**Testimony of LANDMARK WEST!
Certificate of Appropriateness Committee
Before the Landmarks Preservation Commission
7 West 82nd Street
TBD, 2009**

The Certificate of Appropriateness Committee wishes to comment on the application to legalize work performed at the primary façade and areaway without Landmarks Preservation Commission permits at 7 West 82nd Street, a Renaissance Revival style rowhouse designed by Thom & Wilson and built in 1886-87.

Designation photo:
Taken in 1990 at the
time of the designation
of the Upper West
Side-Central Park West
Historic District.

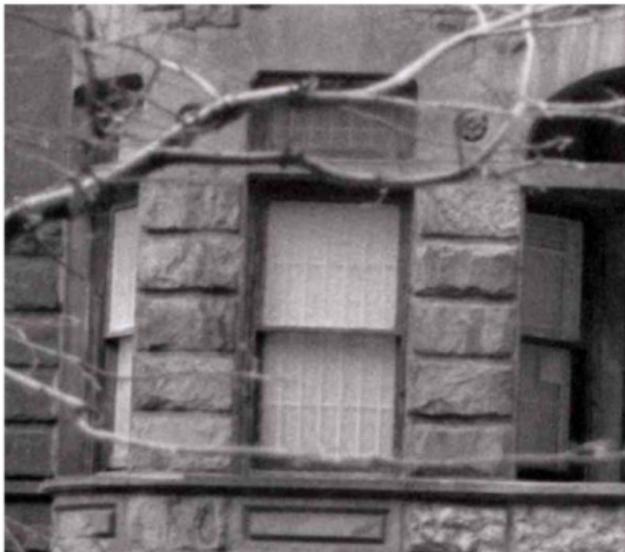
First floor window (see handout page 2): Via conversation with the applicant, it is our understanding that the transom window at the parlor floor level was thought to possess a stained glass, "special" window at the time of historic district designation (1990). By zooming in on the designation photo, it appears that what may look like window leading is more likely security gating installed on the inside of the window.

3

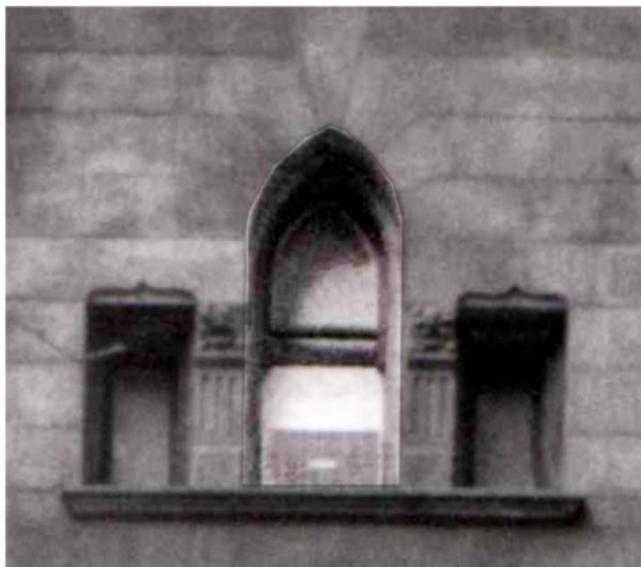
Third floor special window (see handout page 3): As with the first floor window, zooming in on the designation photo to inspect this arched window proved essential in determining that inappropriate modifications have been made to this "special" window. The designation photo (1990) depicts the curving window frame. Looking then to photos of the existing conditions, we can see that inappropriate aluminum panning has been installed in front of the window—and the window itself seems to have been replaced following designation. Both of these were done without LPC permits and should be folded into the portfolio of noncompliance issues being addressed at 7 West 82nd Street.

Top: Using Photoshop to lighten the shading created by this special window's arched stone surround, the curvature of the window at the time of designation (1990) is visible.

Bottom: Existing conditions photo of the special arched window, showing that in addition to replacing the window (without LPC permits), inappropriate aluminum panning has been installed.
